Case Number: 2020.0295.VA0002

Request: Variance from Required Building Setbacks

### SITE PLAN REVIEW AND VARIANCE 2020.0295.VA0002

#### FINDINGS OF FACT AND CONDITIONS OF APPROVAL

SITE PLAN

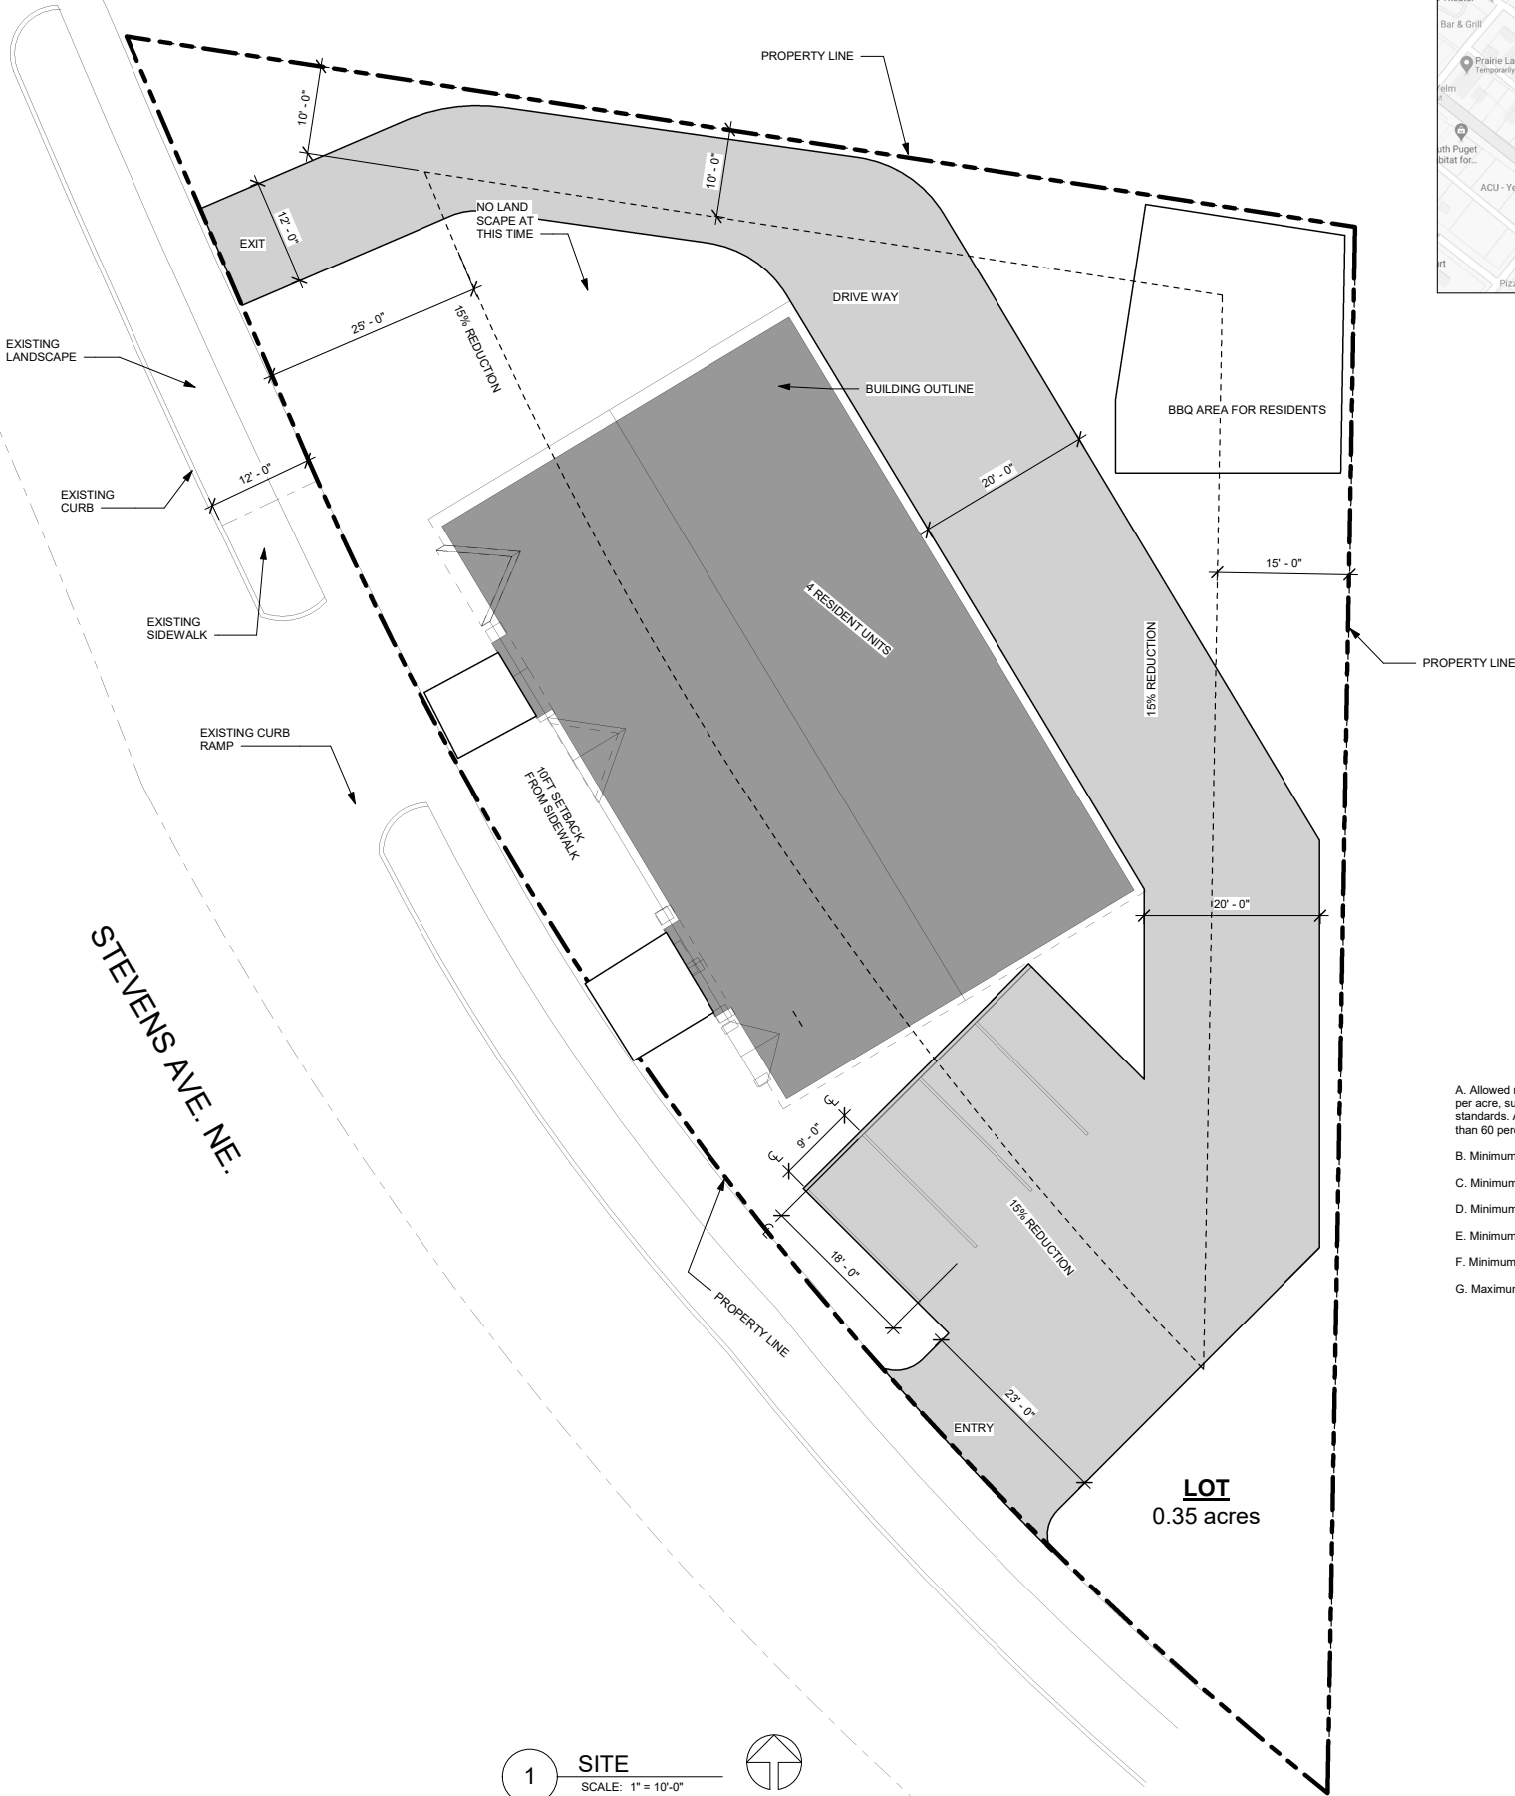
- g. Multi-family dwelling units require two off street parking spaces per unit. [Section 18.54.030 YMC] Standard parking stalls are 9'x20' as shown in Detail 2-22 of the Yelm Engineering Specifications and Standard Details. The proposed site plan shows the farthest parking stall to the north at 9'x19' feet and directly against the building. This does not meet minimum standard for parking and does not provide adequate vehicle overhang at a wheel stop.

The applicant proposes a 6-foot solid wood fence as perimeter landscape, which is an allowed exception for single-family residences. In this instance, the property is bordered by commercial development to the east, and single-family residences to the north, and west. It would be appropriate to allow the solid wood perimeter fence adjacent to the commercial use to the east, as well as between other single-family residential uses.

The proposed landscape plan shows the fence to extend to the back of right of way on both the east and west property lines. Due to the property fronting on the commercial collector and at a curve, the proposed ingress and egress to this site, as well as adjoining property driveways, this will cause a sight barrier for entering and

exiting the site and adjoining properties. In order to meet safety requirements and line of site, the solid wood fence will need to end at a minimum of 20 – 25 feet from the back of right-of-way, and 8 foot landscaping installed. The landscaping in these areas shall provide for shrubs and ground cover to provide the visual and physical barrier, while not obstructing line of site.

The proposed site plan provides for a landscape island with tree at the north end of the parking stalls, but does not include landscape for the southern end of the parking area. There are sewer service lines located in the area, and required landscape should provide clearance to these lines. Parking lot landscape is required where there are not utility conflicts.

The site plan does not show mailbox location. Civil engineering plans shall include the location of onsite cluster box units.

The site plan is not clear if parking or walkways will be lighted. Civil engineering plans shall include an illumination plan if onsite lighting is proposed.

The conceptual utilities plan shows location of S.T.E.P. tanks to the side of the building, adjacent to and crossing waterlines. A 10-foot separation is required between these lines. When this separation cannot be achieved, or these lines cross, they must be sleeved.

1. Setbacks shall be based on the approved variance request of 10-foot front yard setback and 10-foot side yard setbacks. The 25 foot rear yard setback is reduced at the eastern building line.

2. Parking stalls shall be 9' x 20' feet with adequate vehicle overhang at the building.
3. The civil engineering plans shall include a detailed landscape plan that includes:

- a. The solid wood fence on the perimeter shall not extend within 20 feet of the back of right of way to allow for line of site requirements.
  - b. Perimeter landscaping from the end of the solid wood fence to the back or right of way.

- c. Perimeter landscaping is required along the property frontage, where not in conflict with utilities.
  - d. Parking landscaping shall be included around all of the parking area where not in conflict of utilities.

5. Civil engineering plans shall include an illumination plan for any onsite lighting.
6. Civil engineering plans shall include the location of onsite cluster box units.
